**Project:** Lincoln Public Schools - Belmont Elementary School – Indoor Air Quality Improvements  
3425 North 14th Street, Lincoln, NE 68521

**Project No.:** Engineers Project No.: 2016-136

**ADDENDUM #1**

CAD-01

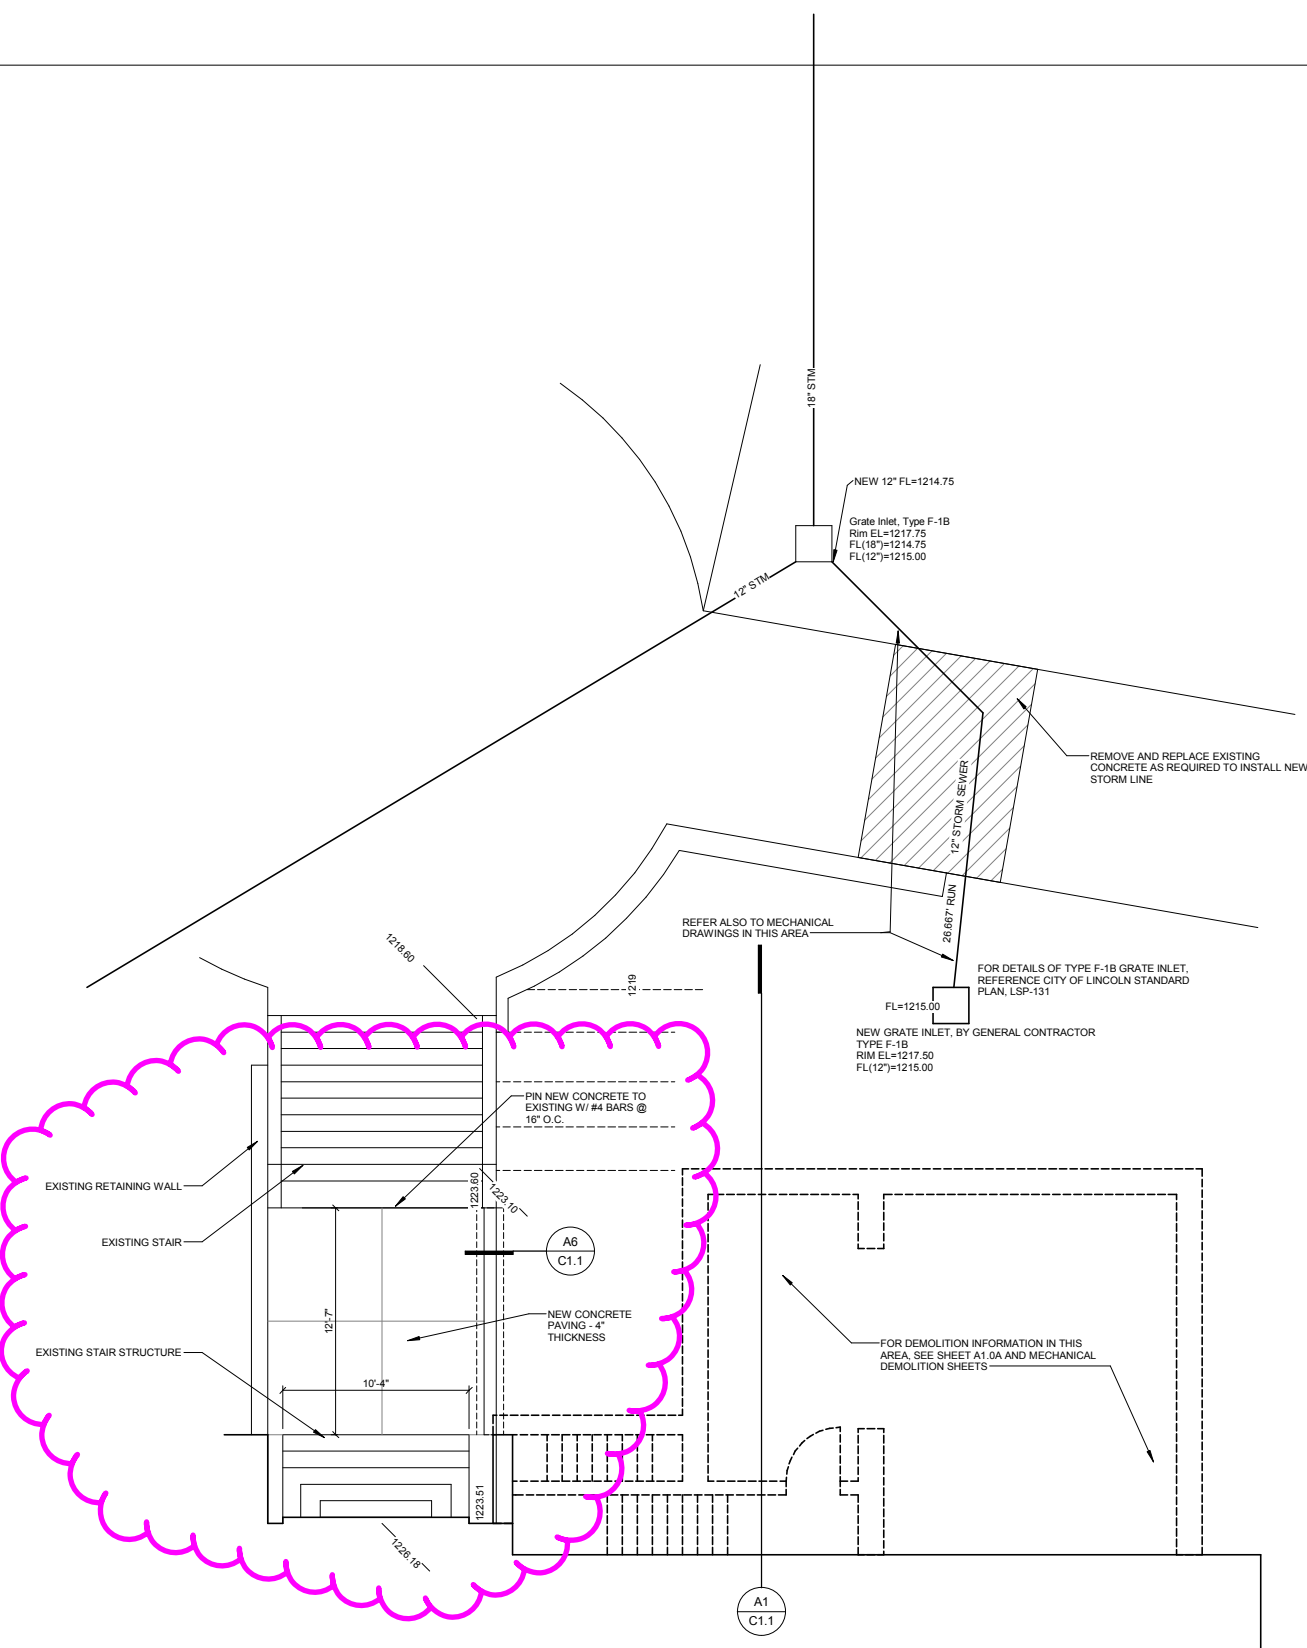
- A. Sheet C1.0 – SITE PLAN (not reissued).
  - 1. Sheet Specific Notes on this sheet begin with Note 2. Note 1 was not used.
  - 2. On the east side of the existing Educare Building, north of the north portable classroom is a note regarding the new transformer location. A supplemental drawing has been included with this addendum to clarify the extent of concrete work at this location. See CAD-01 included with this addendum.

**G1**      **NE ENTRY ENLARGED PLAN**      **F9**

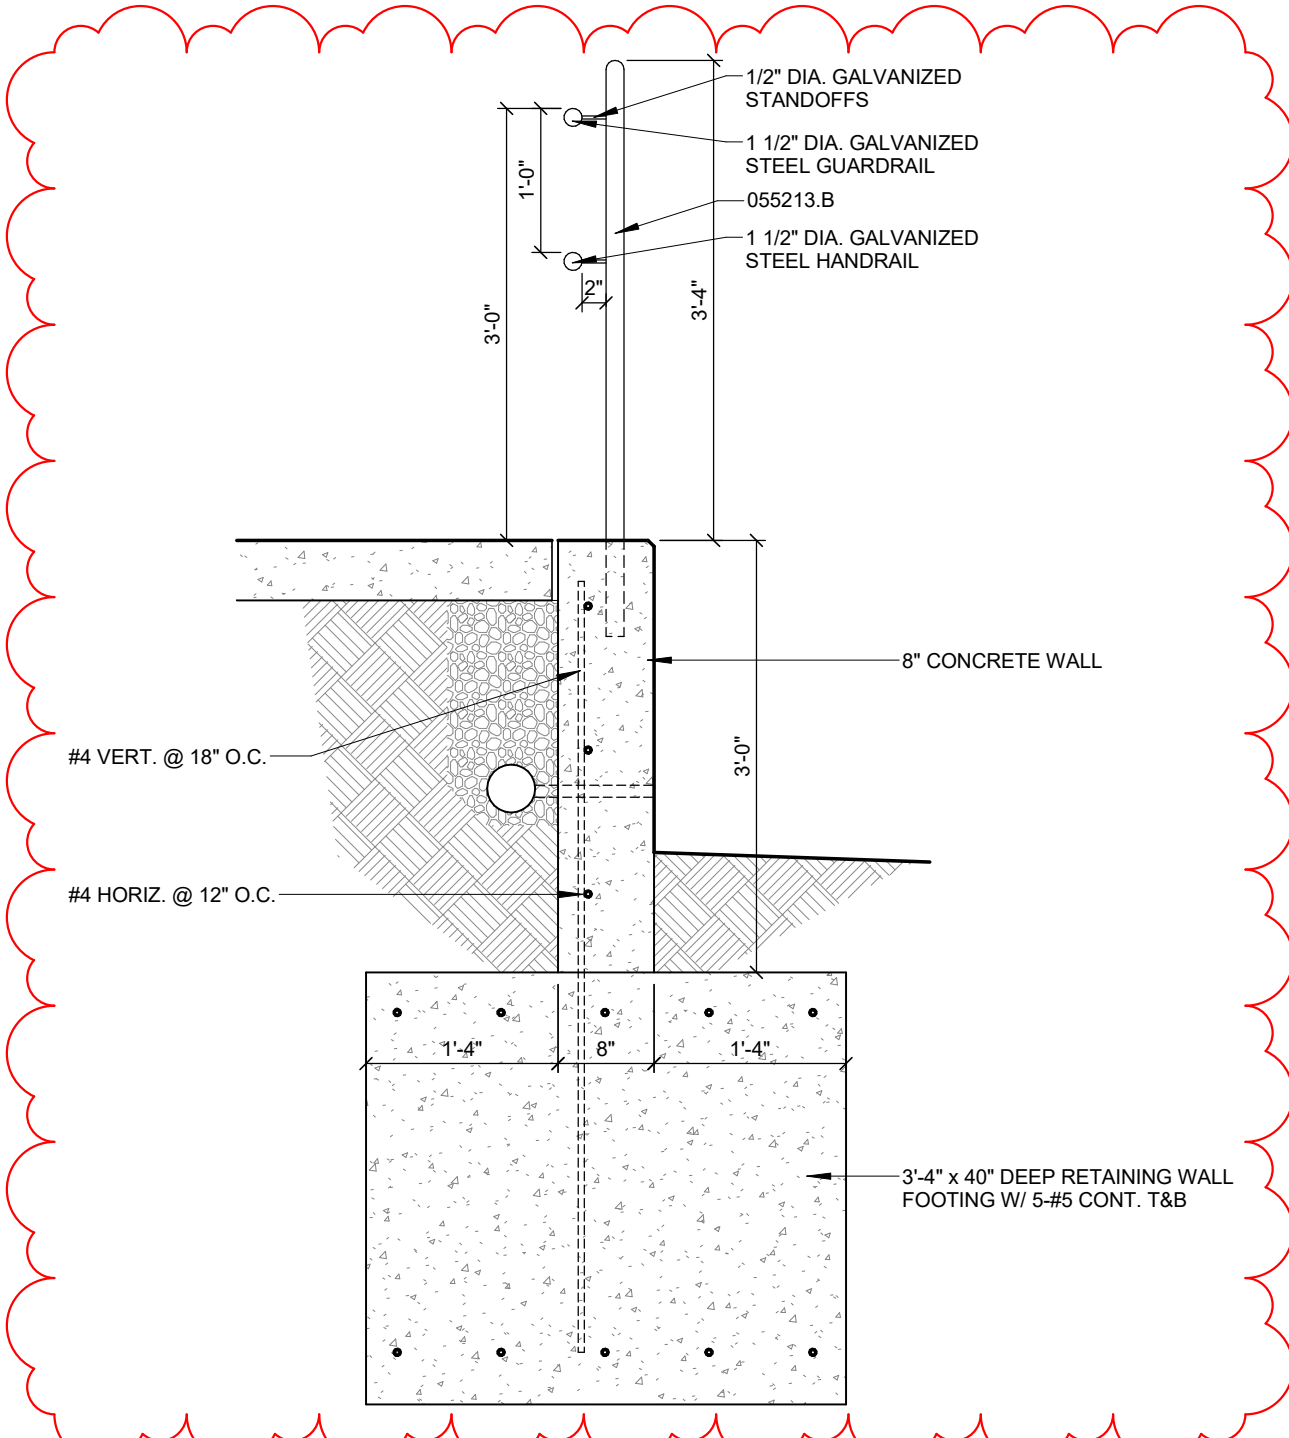
- B. Sheet C1.1 – ENLARGED SITE PLANS AND DETAILS (not reissued).
  - 1. Refer to G1 NE Entry Enlarged Plan: Additional notes have been included on the attached supplemental drawing. See CAD-02 included with this addendum.

A6

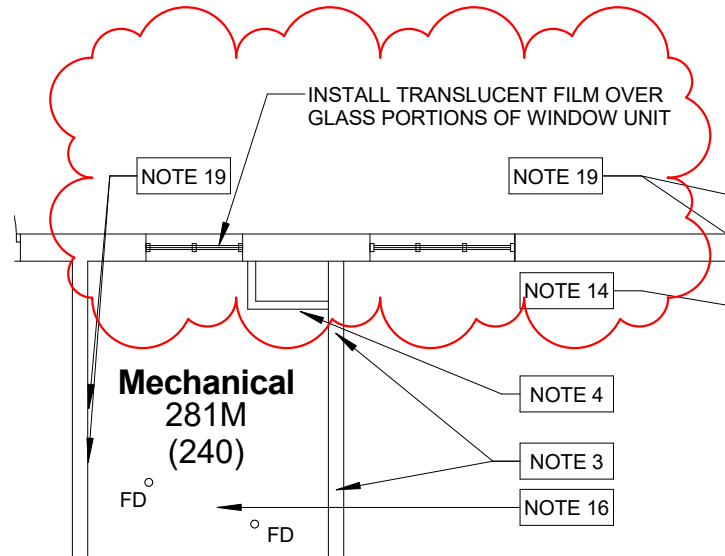
- C. Sheet C1.1 – ENLARGED SITE PLANS AND DETAILS (not reissued).
  - 1. Refer to A6 Retaining Wall at NE Entry: Additional notes and revisions have been included on the attached supplemental drawing. See CAD-03 included with this addendum.

—NEED NOTES

AAD-01  
3-9-17

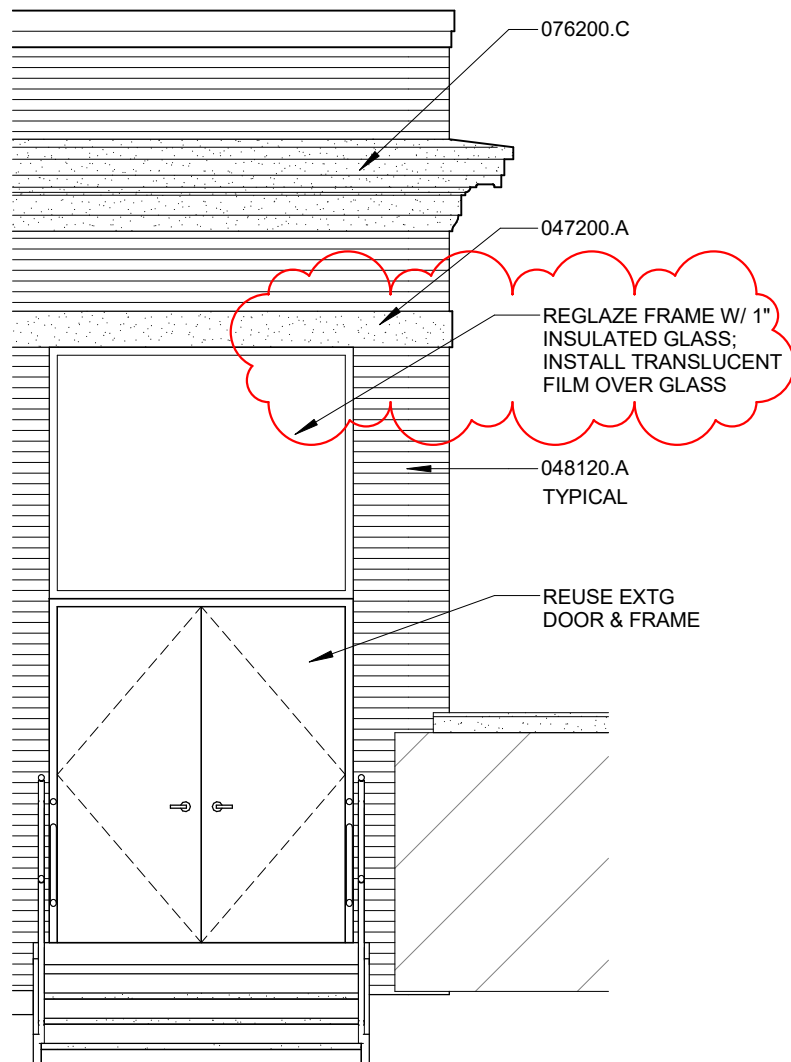
- J. Sheet A5.0– EXTERIOR ELEVATIONS (not reissued).
  - 1. The glass of the transom above the door (door 382Mb) in Mechanical 382M is to have translucent film applied to the interior of the glass. See AAD-01 included with this addendum.

AAD-02

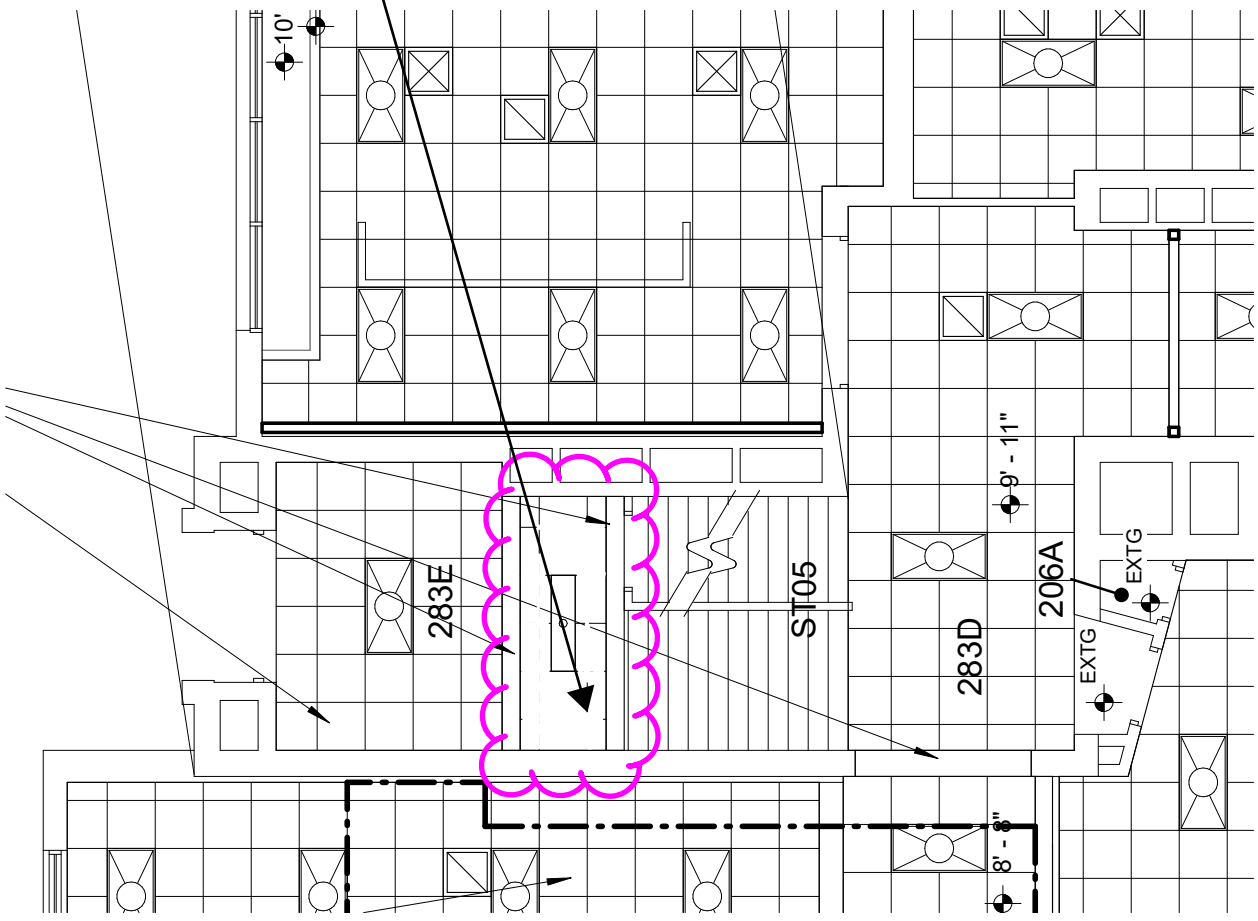
- I. Sheet A3.2A – SECOND FLOOR REFLECTED CEILING PLAN – AREA A (not reissued).
  - 1. In the Northeast corner of the Building, Stair ST05, the lay-in ceiling indicated between the two existing bulkheads is to be deleted. The existing plaster ceiling in this location is to remain but will require repair prior to being painted. See AAD-02 included with this addendum.

ELIMINATE LAY-IN CEILING  
FROM BETWEEN EXISTING  
BULKHEADS. REPAIR  
EXISTING PLASTER CEILING -  
PAINT FINISH

New Transformer and Pad

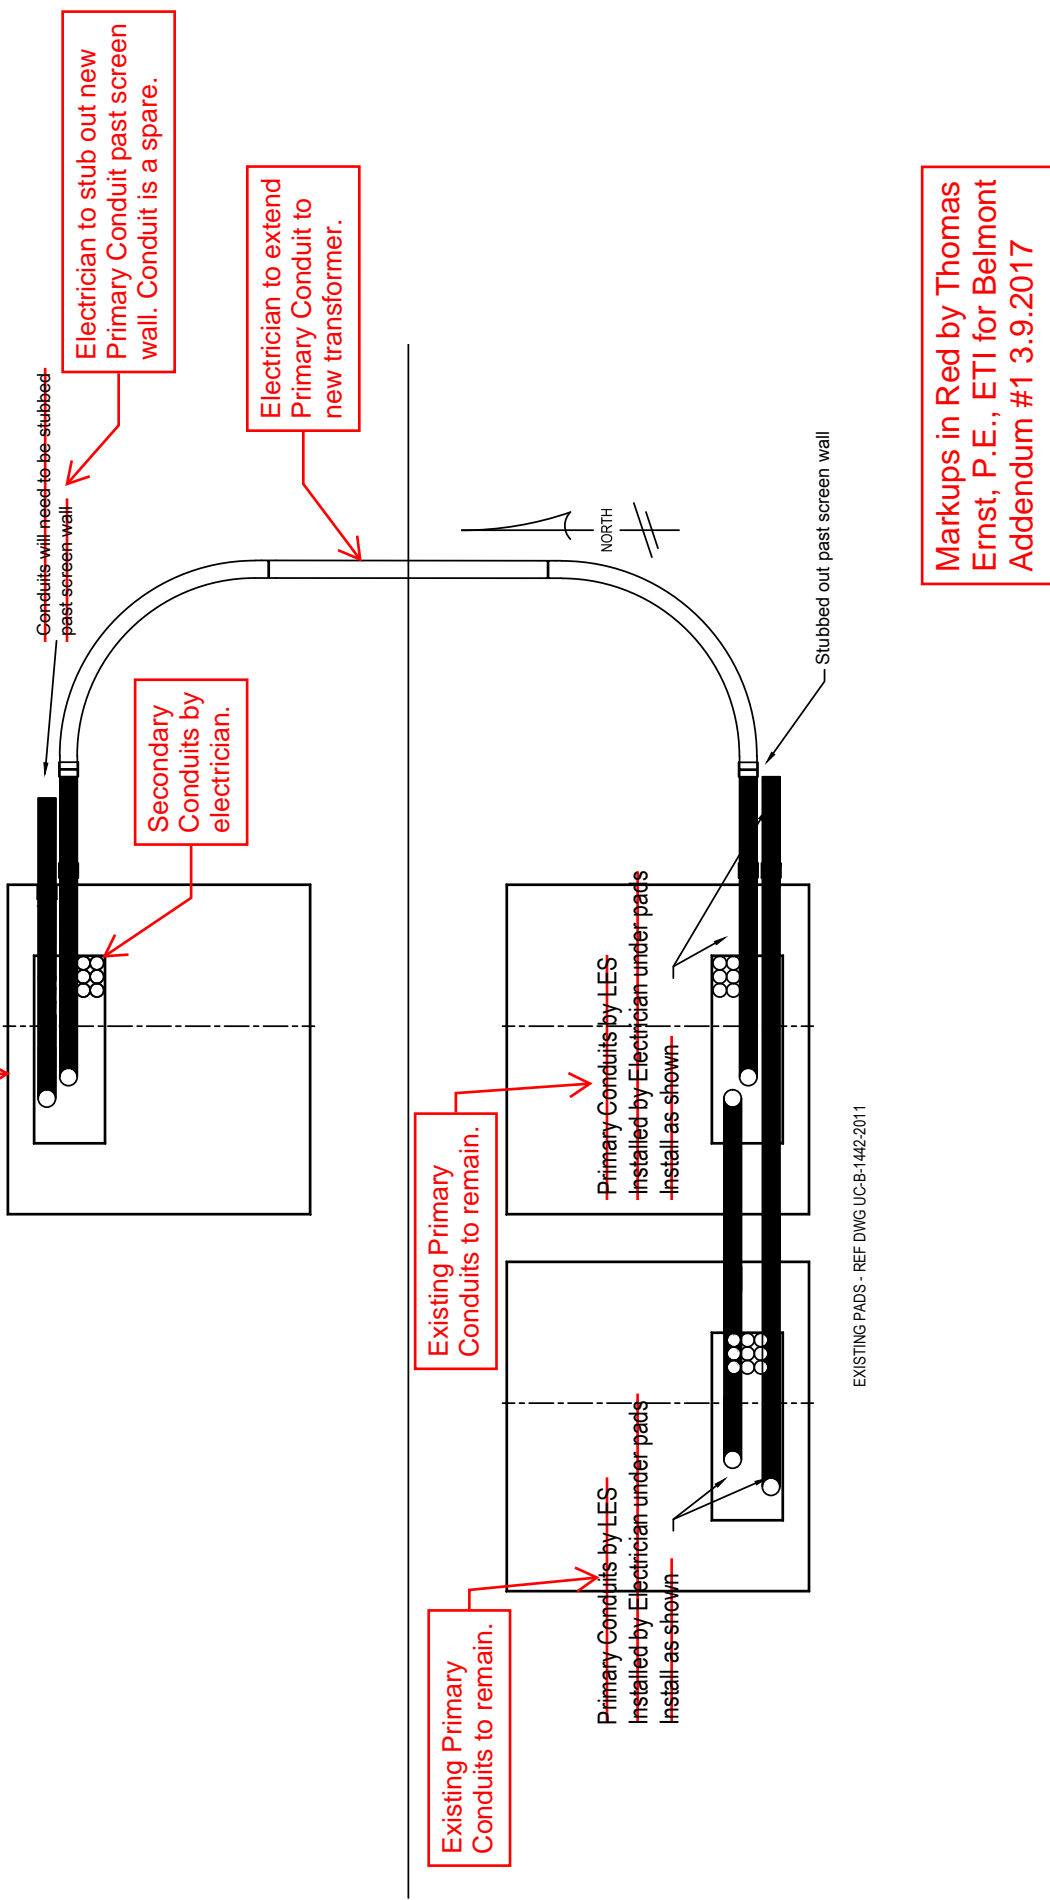
- A. Transformer Pad
1. See included LES transformer pad details with Electrical Engineer notes.
- B. The General Note below should be added to all Electrical drawings.

Markups in Red by Thomas Ernst, P.E., ETI for Belmont Addendum #1 3.9.2017

SHEET  
**E1.1A**

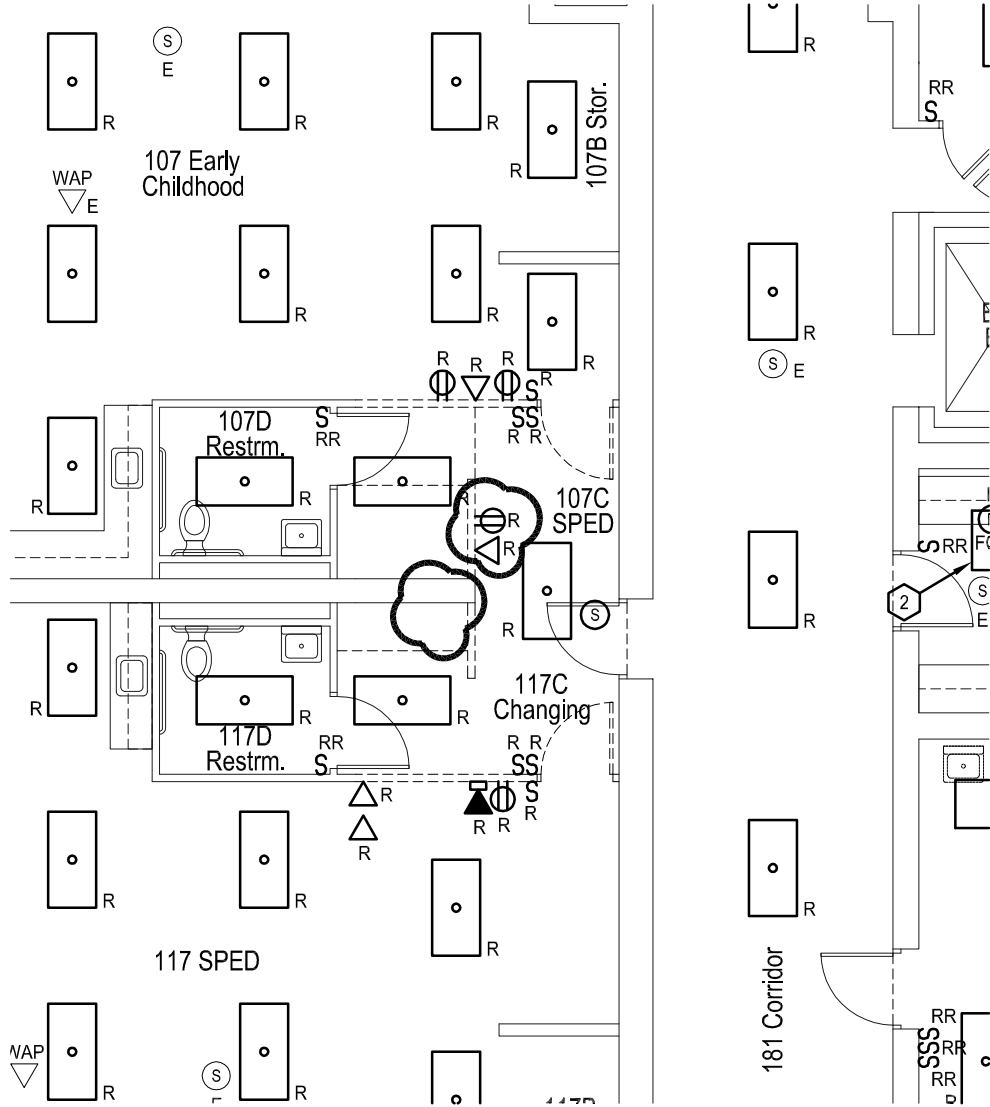
- A. Sheet E1.1A FIRST FLOOR PLAN – AREA A – ELECTRICAL DEMOLITION, (not reissued)
  - 1. See enclosed drawing Sheet E1.1A, Attachment #1, dated 3.9.2017 for removal of old cat5 data.
